LCR# 85-07

ATTACHMENT A

MARKED-UP SALEM FSAR SECTION 15.4.8.2
STEAMLINE BREAKS

FIGURE 15.4-100

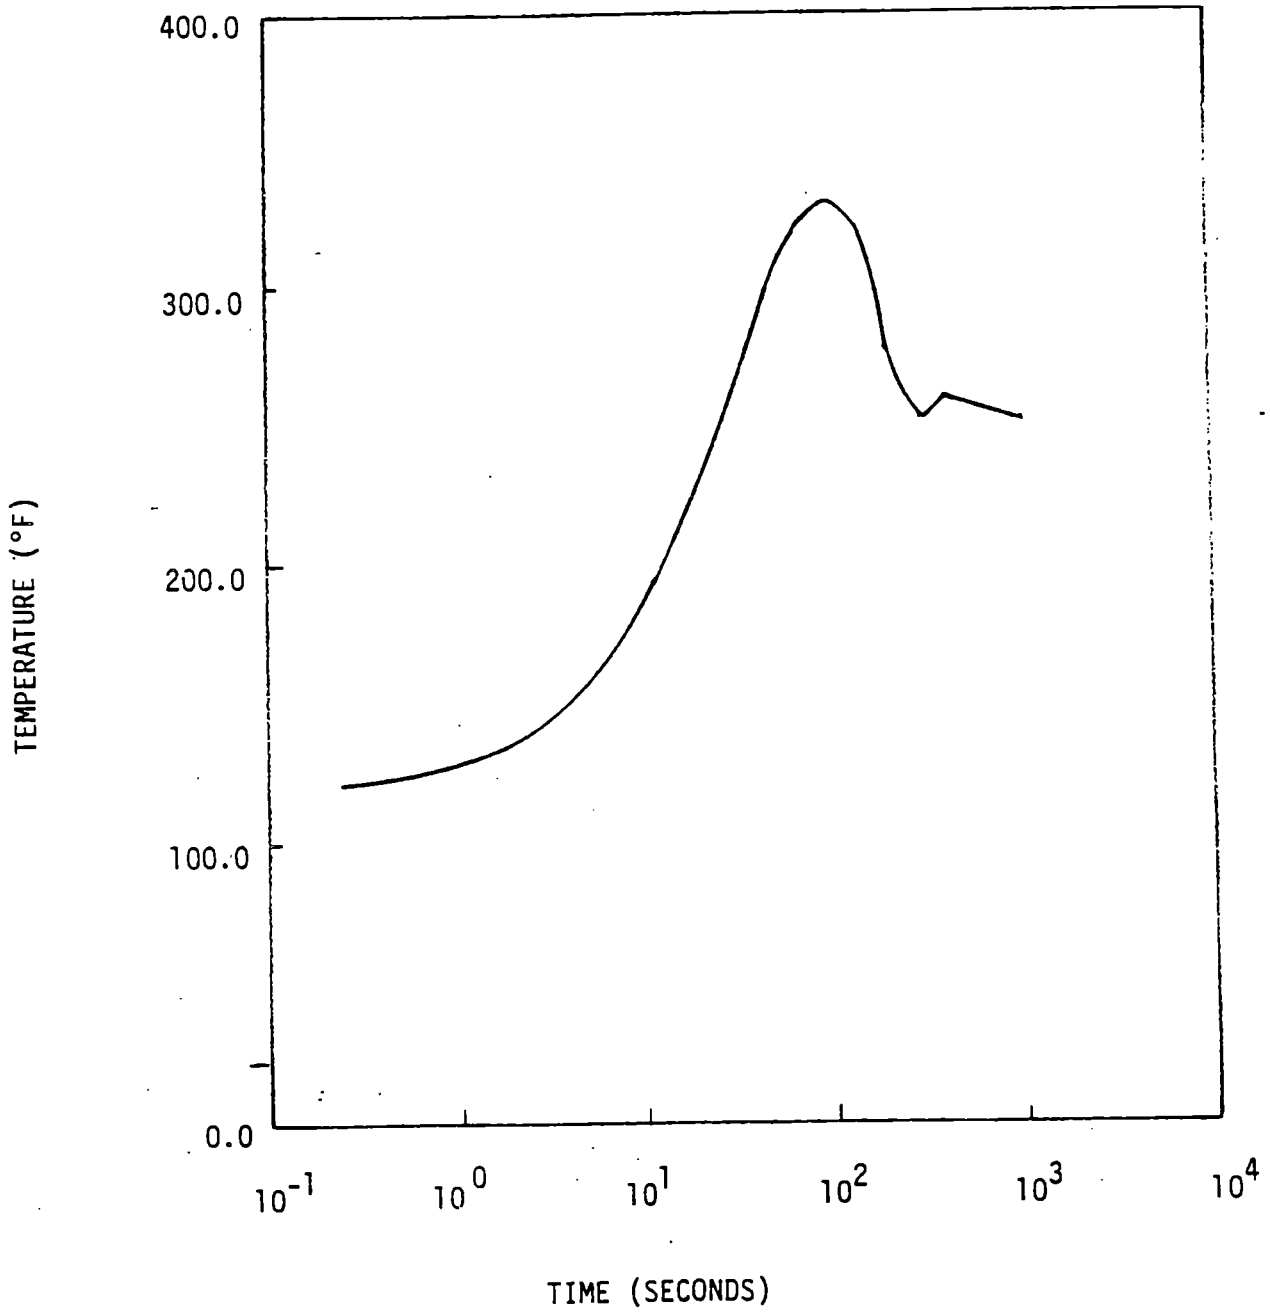
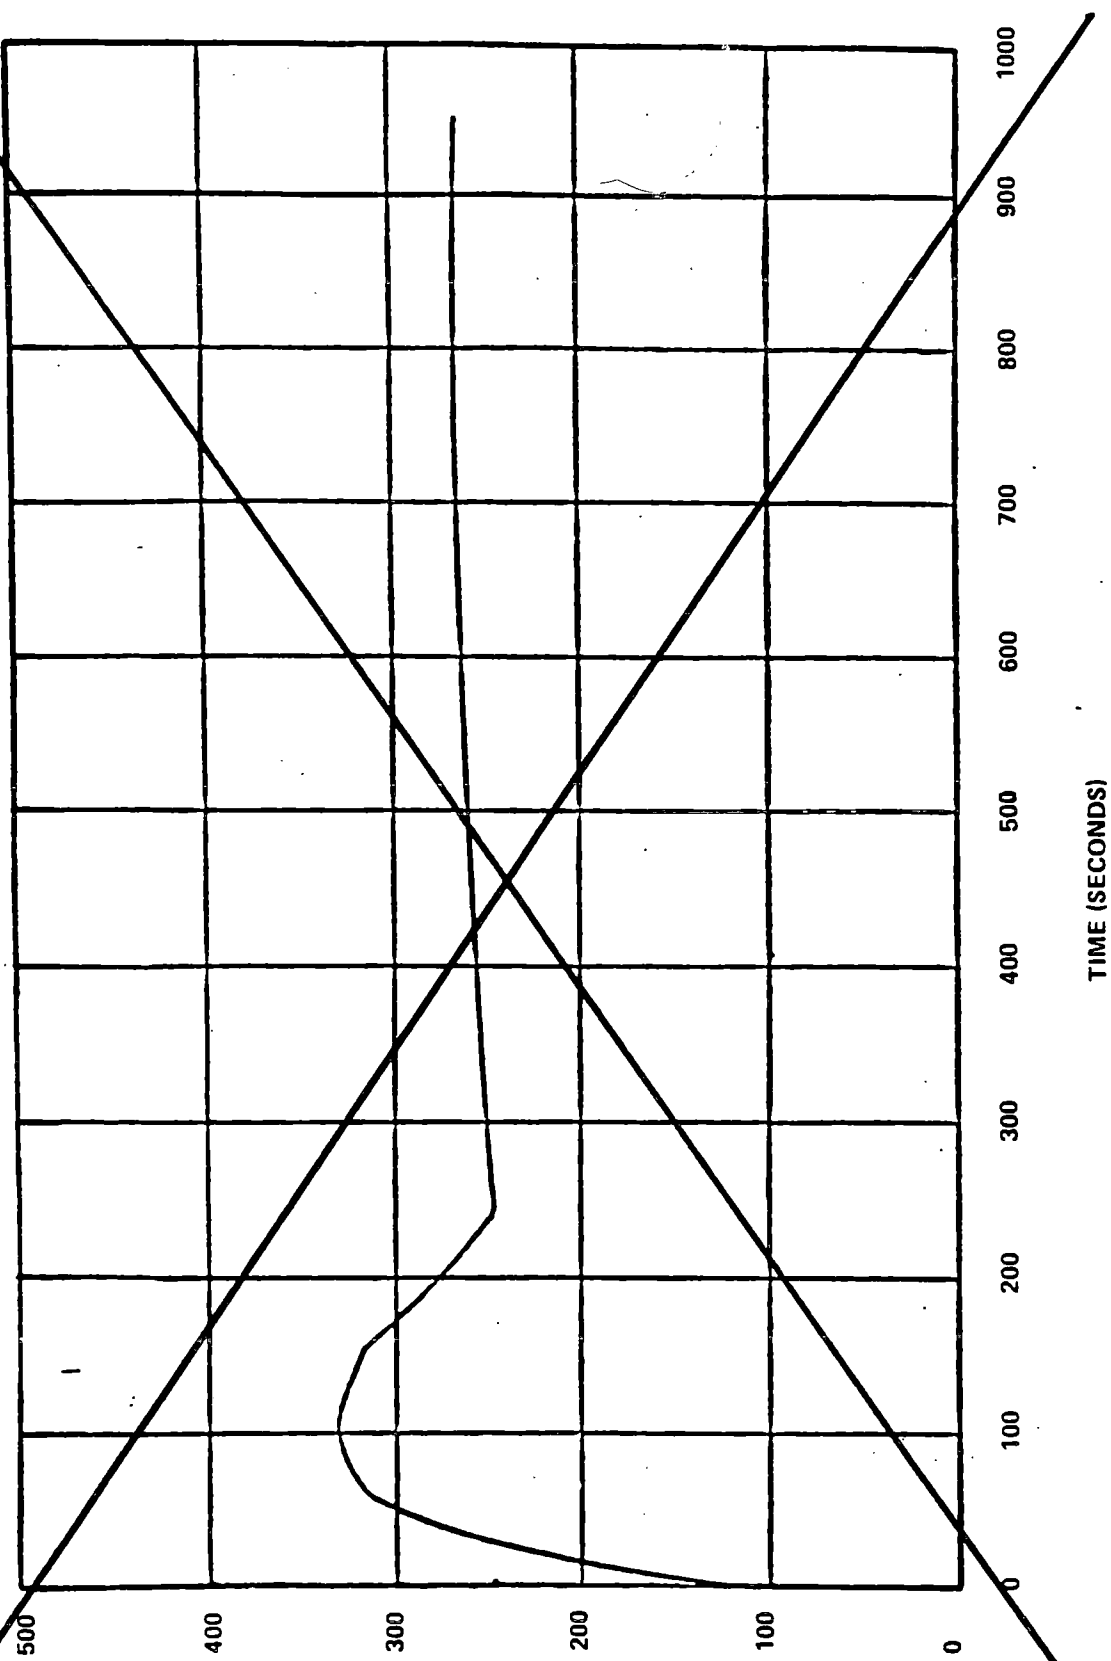
Replace w/ next sheet

FIGURE 15.4-101

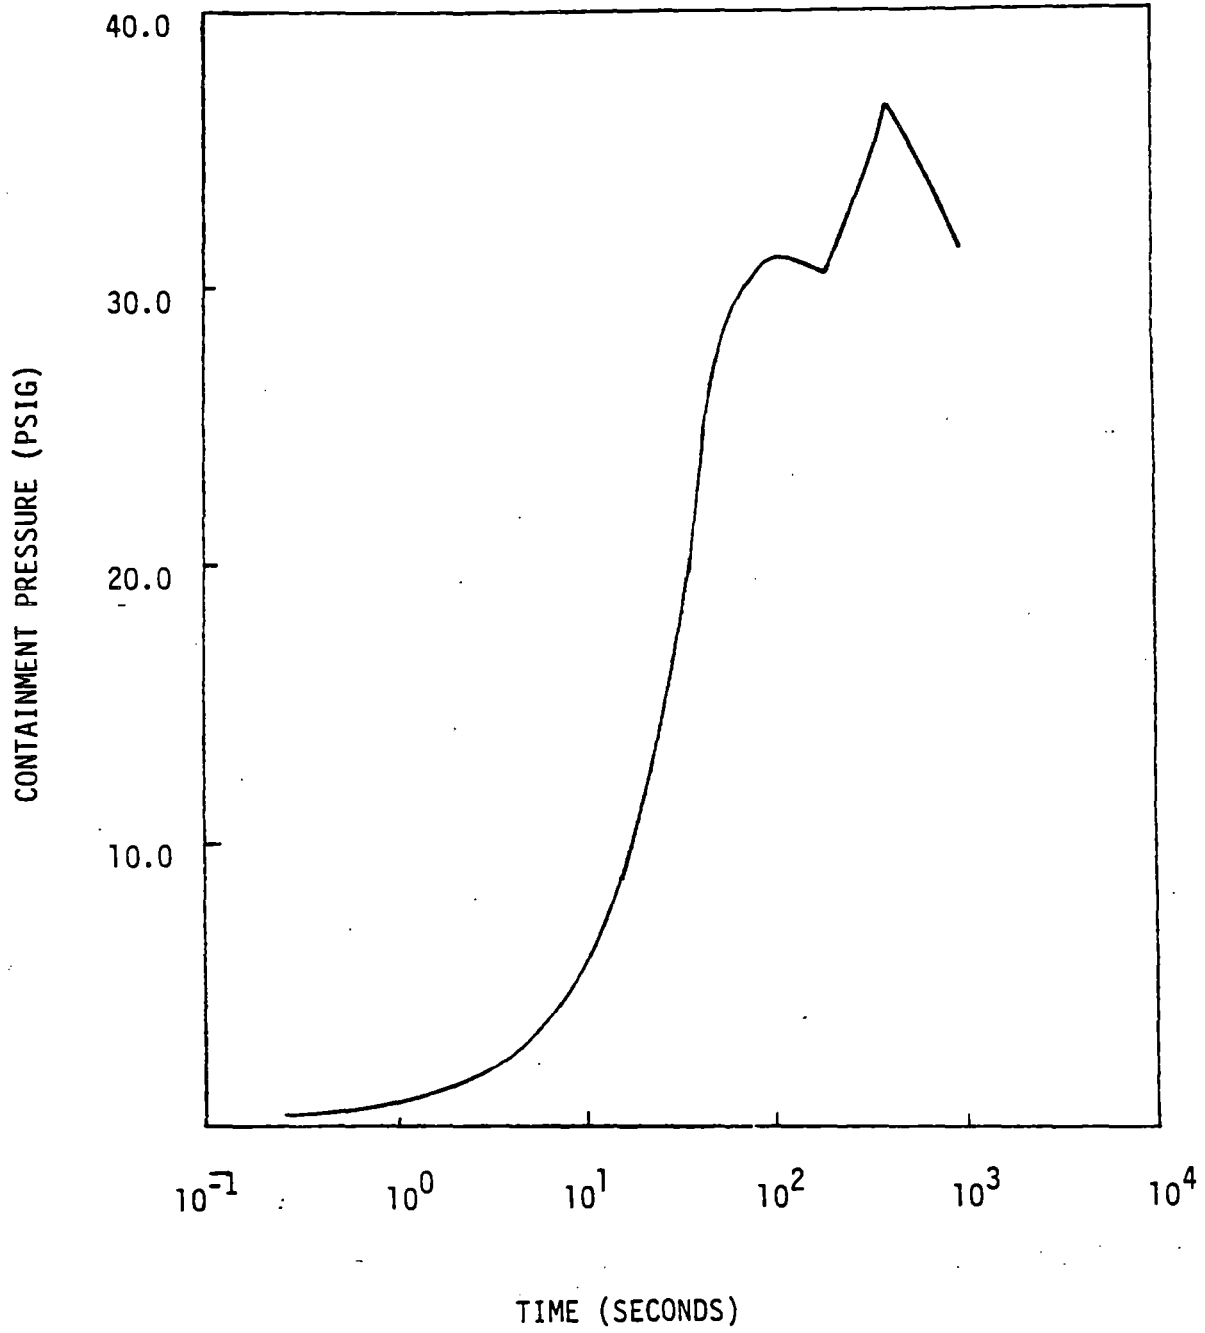
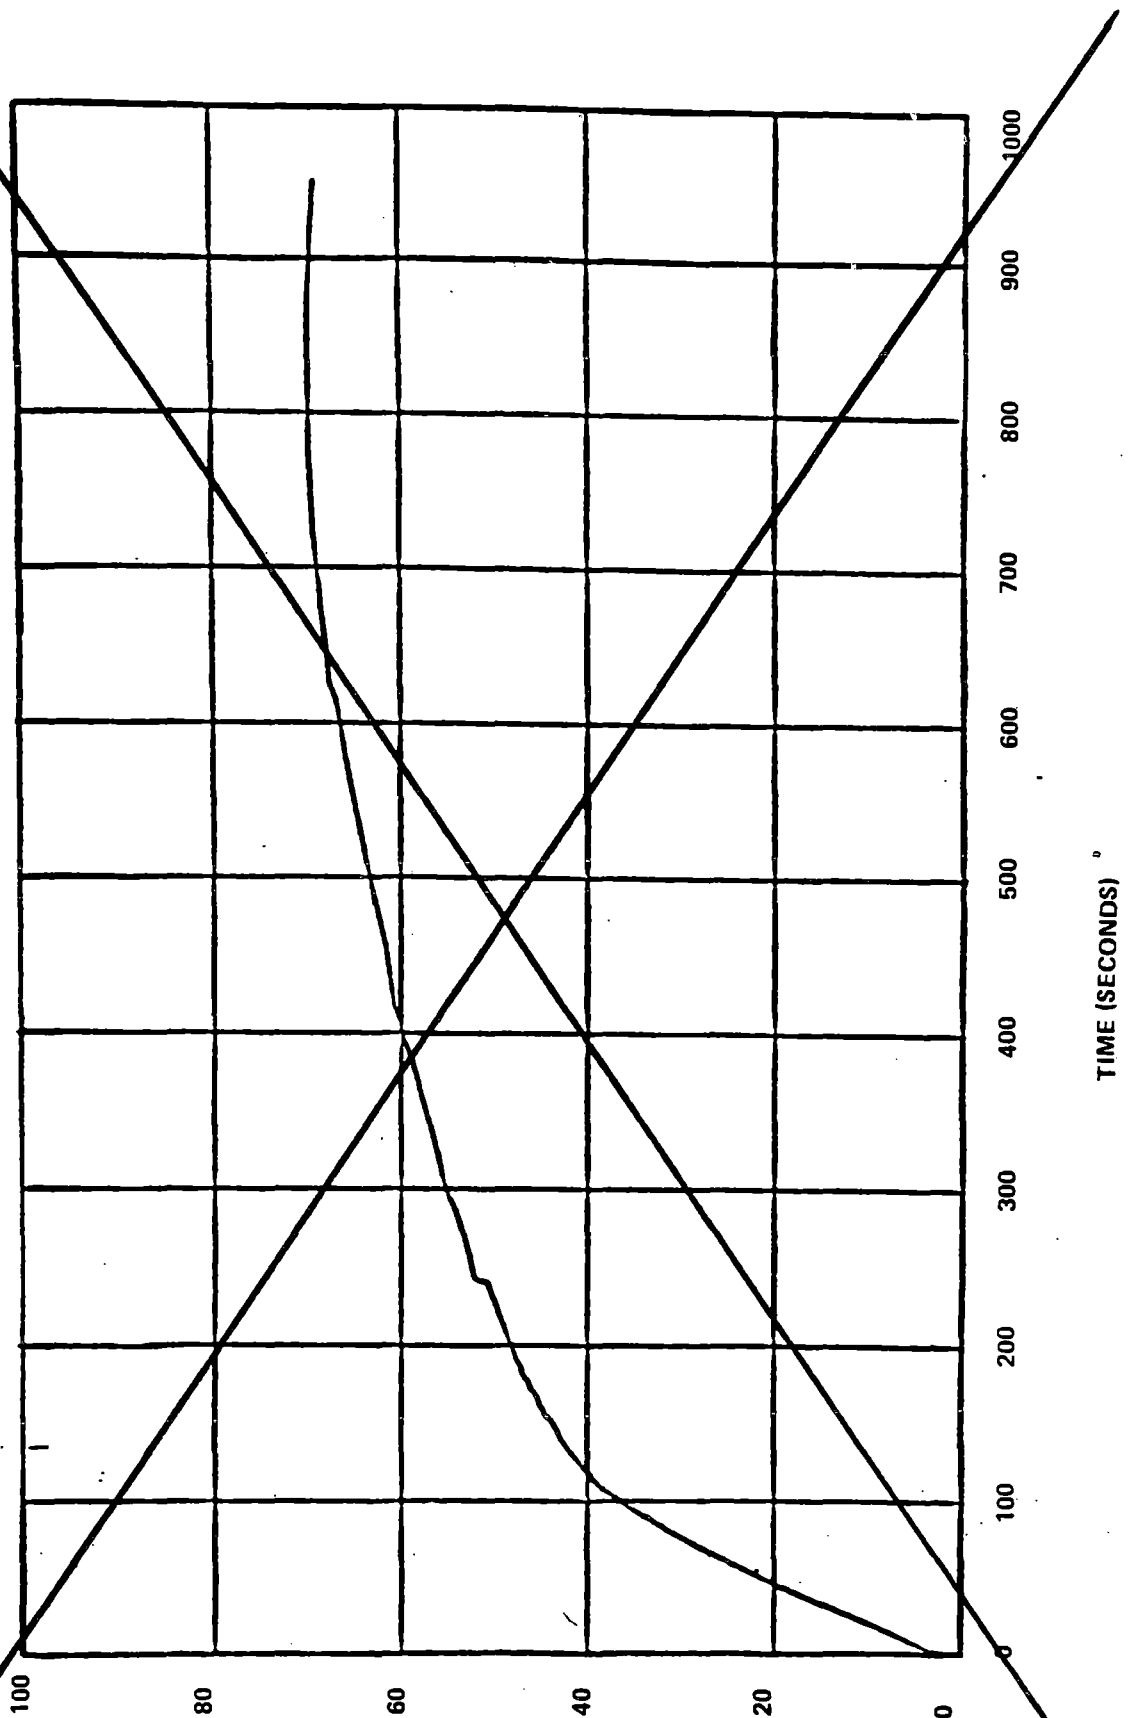
Replace w/ next sheet

FIGURE 15.4-102

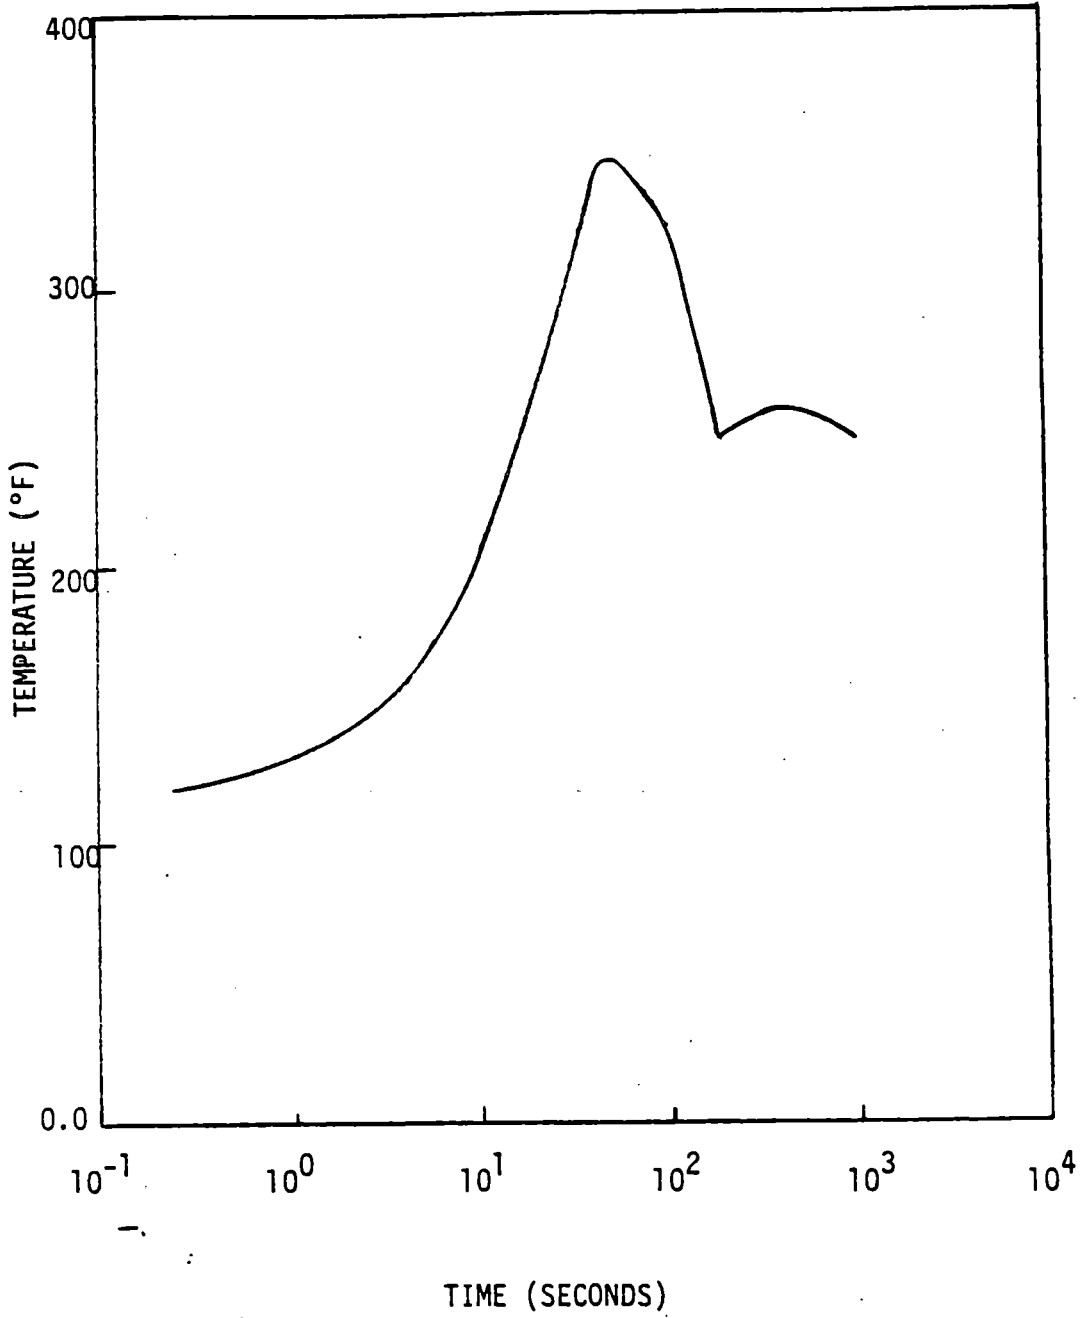
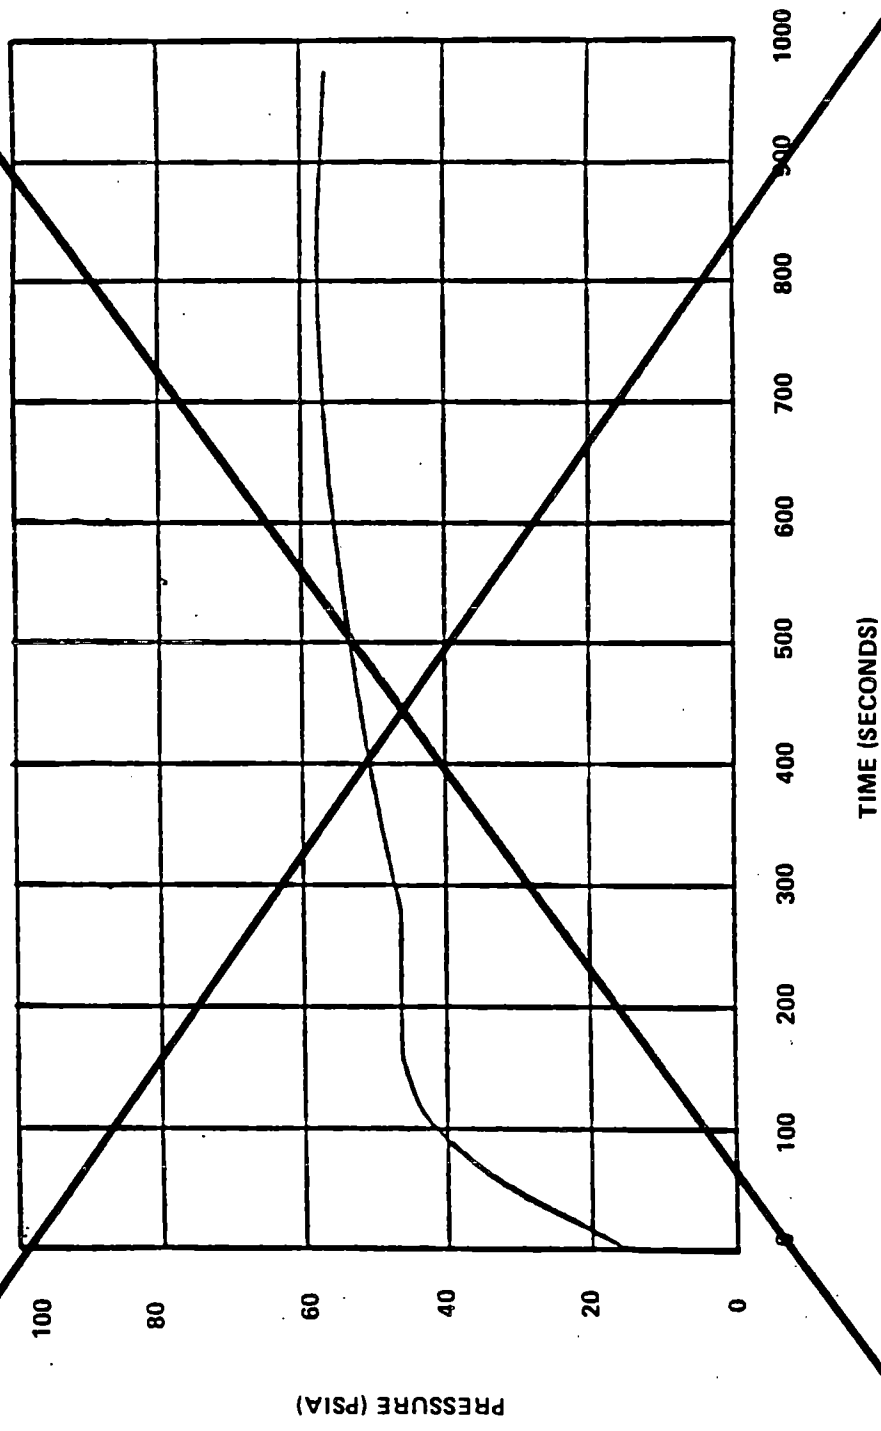
Replace w/ next sheet

Containment Heat Coefficient for 0.860 FT2
 Split Break at 102% Power with
 Minimum Safeguards (NRC Model)

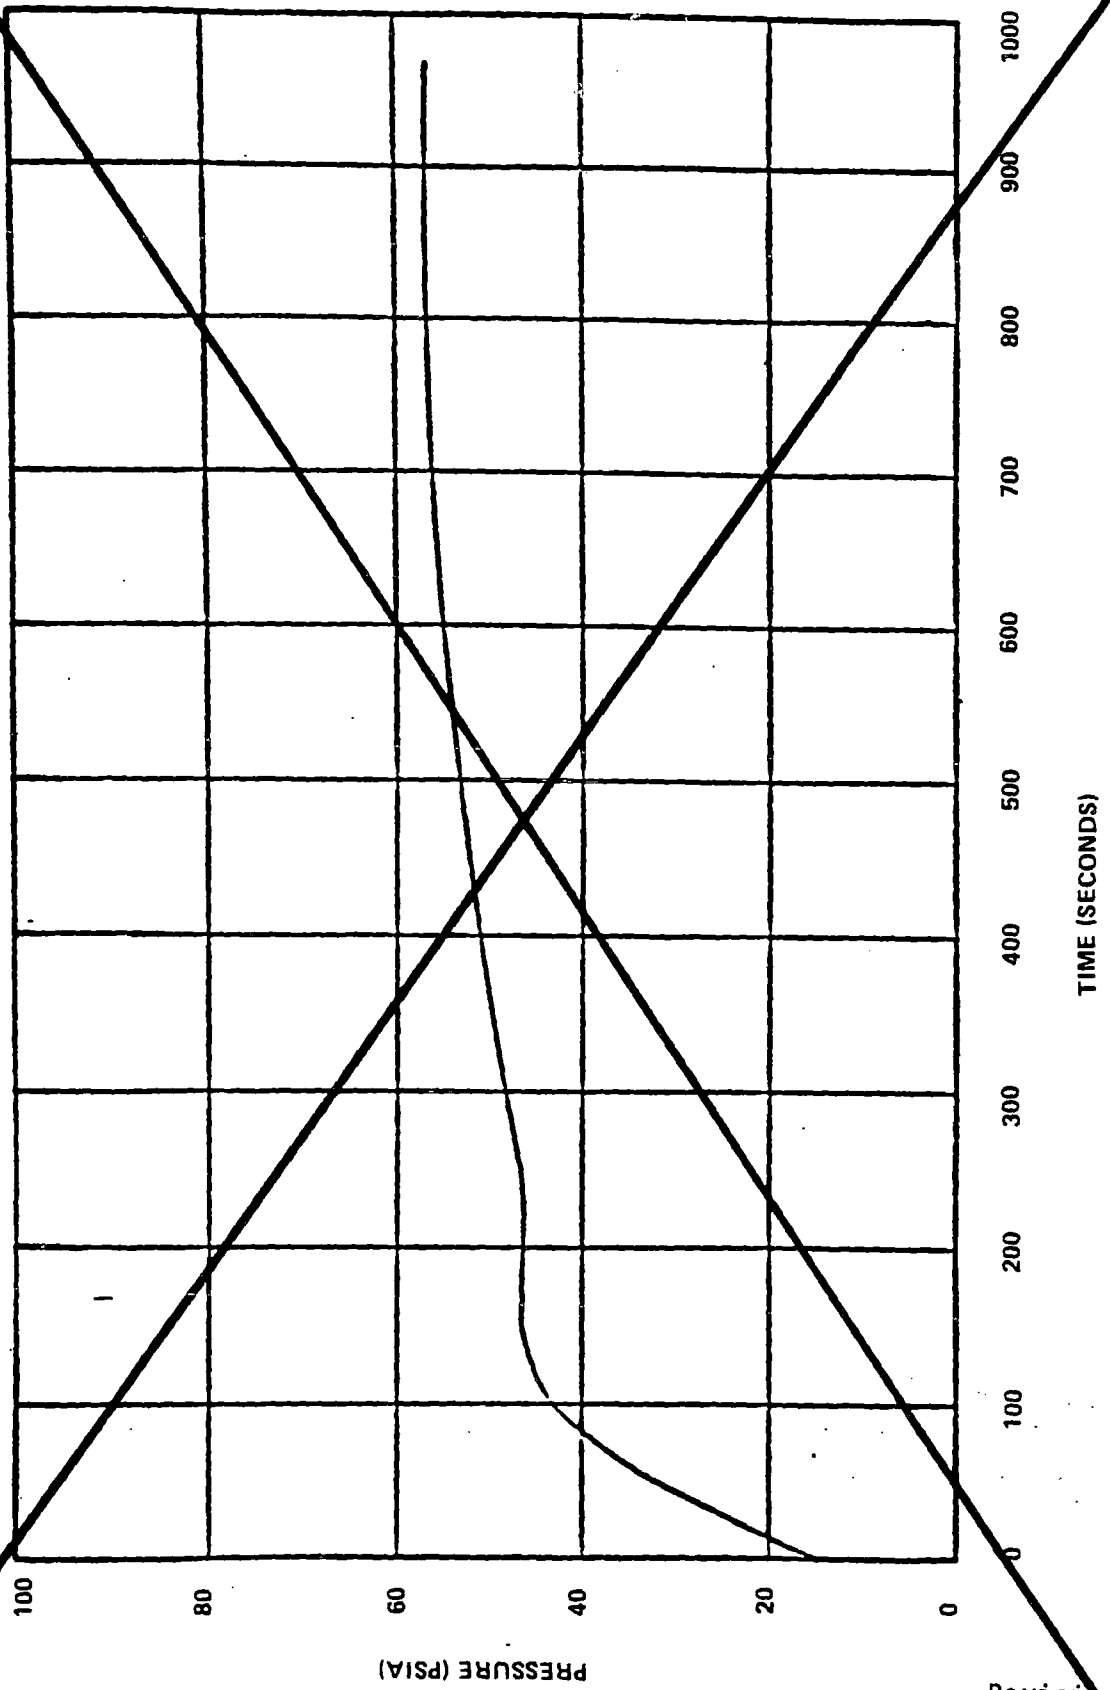
Updated FSAR **DELETE**
